ACTION TRANSMITTAL No. 2018-09

SUBJECT: Scope Change Request for West St. Paul's Oakdale Avenue Multiuse Trail Project (SP # 173-020-016)

SCOPE CHANGE REQUEST
West St. Paul Oakdale and Marie Trail Extension
City Project 18-4
West St. Paul and Dakota County, Minnesota

A map showing the location of the project and improvements is provided as **Figure 1**.

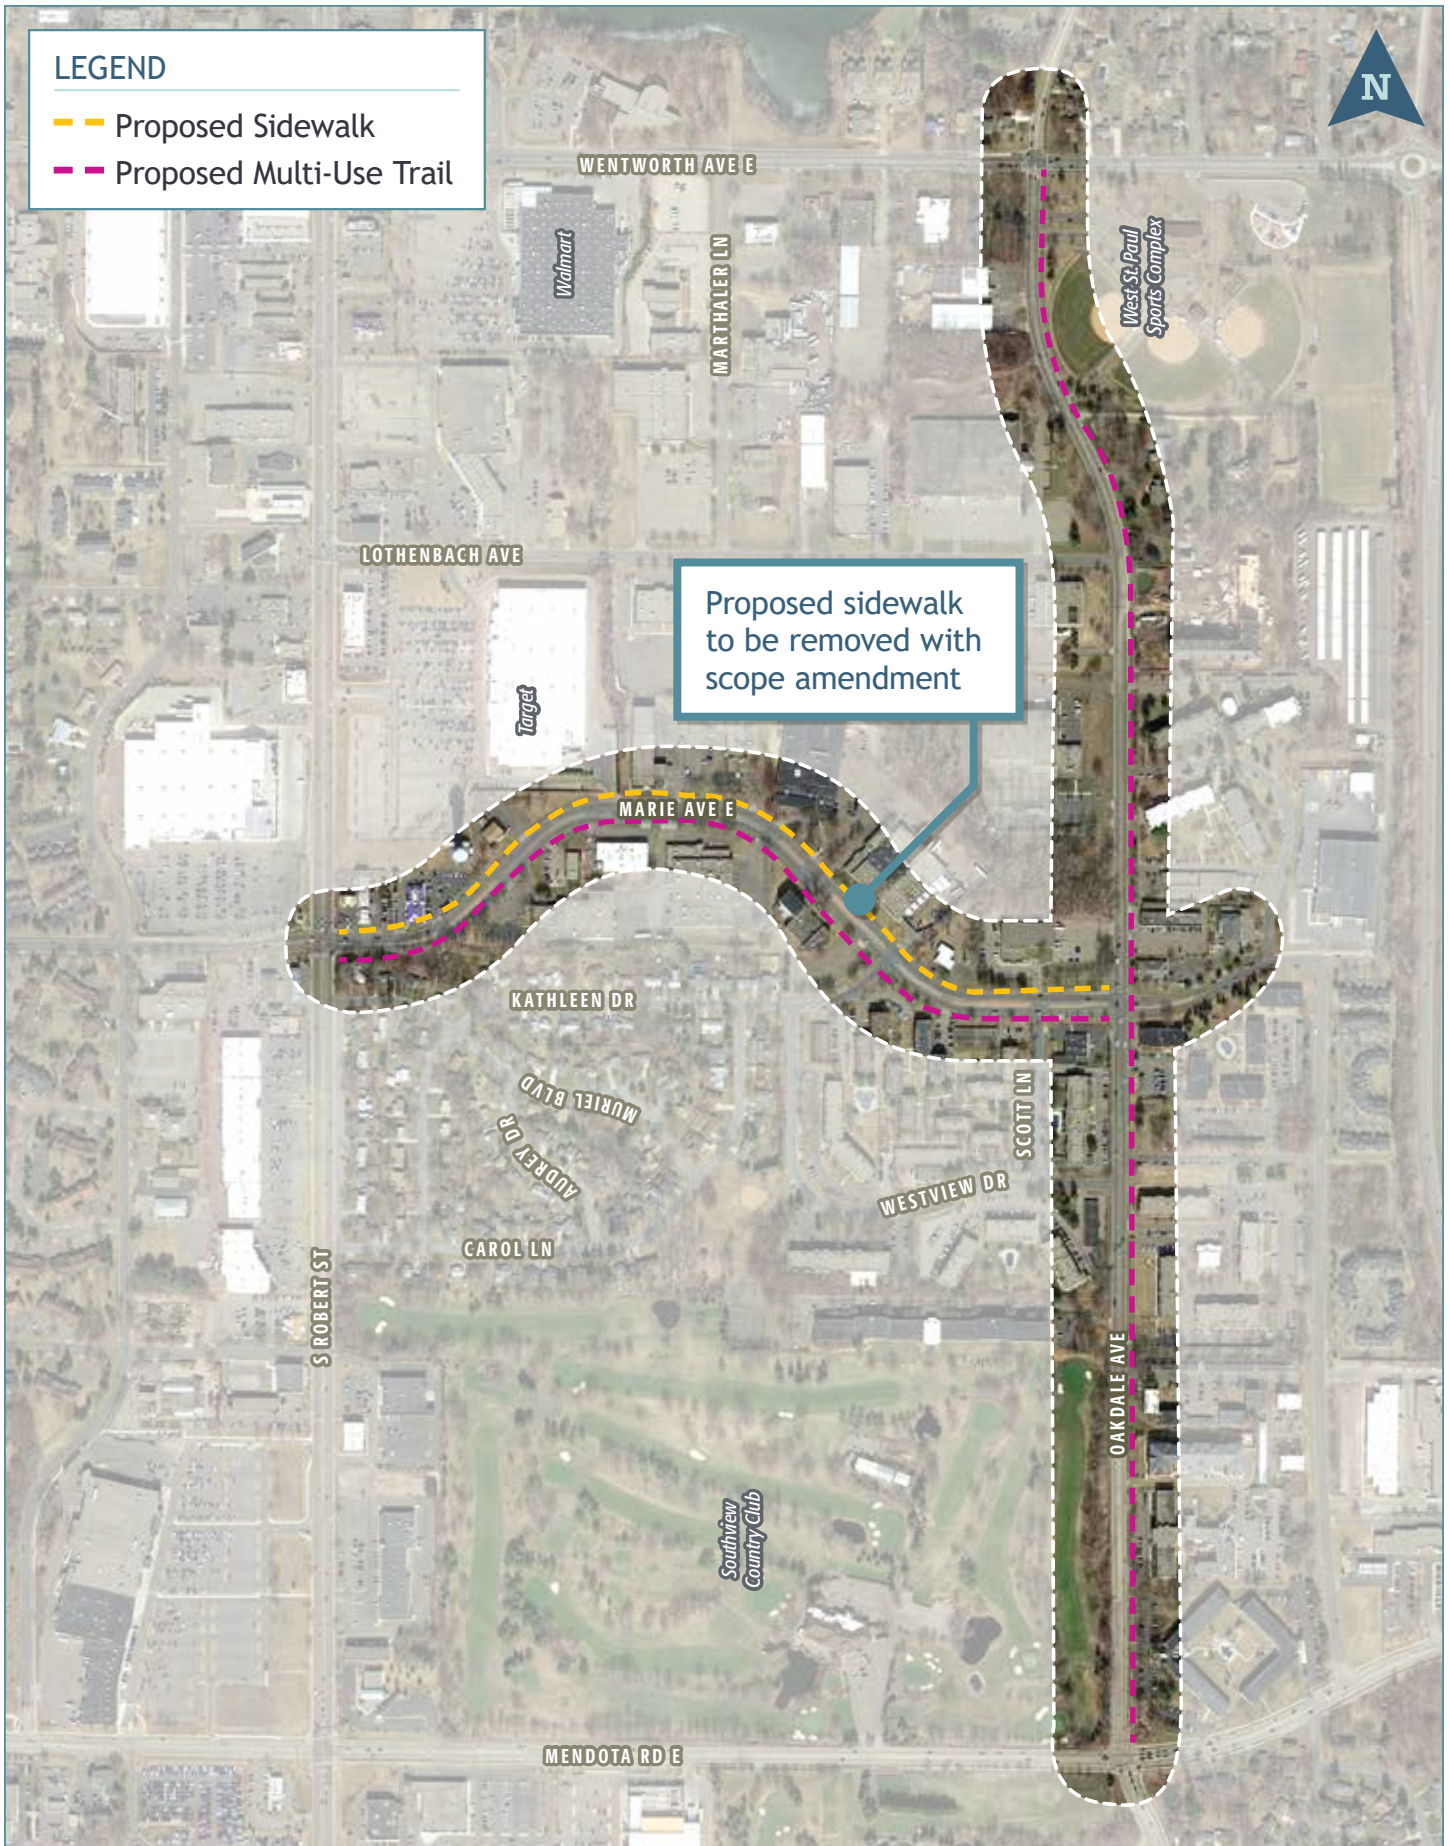
The scope change is the removal of the sidewalk along Marie Avenue from Robert Street (TH 3) to Oakdale Avenue (CR 73). The City is currently in the preliminary design phase of the project and has evaluated the estimated project costs in further detail. At the time of the application, no retaining wall costs or right-of-way acquisition costs were anticipated for the construction of the multi-use trail and sidewalk along Marie Avenue. It has been determined through the preliminary design process that both right-of-way acquisition and retaining wall construction will be necessary for the trail and sidewalk to be constructed.

Since the time of the application, the City has reevaluated the construction costs and design for the trail and sidewalk improvements along Marie Avenue between Robert Street (TH 3) and Oakdale Avenue (CR 73). It has been determined that retaining walls and right-of-way acquisition will be needed to construct the proposed sidewalk along Marie Avenue for this segment. The increased project costs and abundance of property acquisitions along Marie Avenue make constructing the sidewalk politically challenging and financially burdensome for the City. As a result, the City is proposing to remove the sidewalk improvements along Marie Avenue in this segment from the project. This segment of Marie Avenue is a priority gap in the City's Pedestrian and Bicycle Master Plan and the proposed multi-use trail along Marie Avenue will still meet the objectives of the project and City's Master Plan.
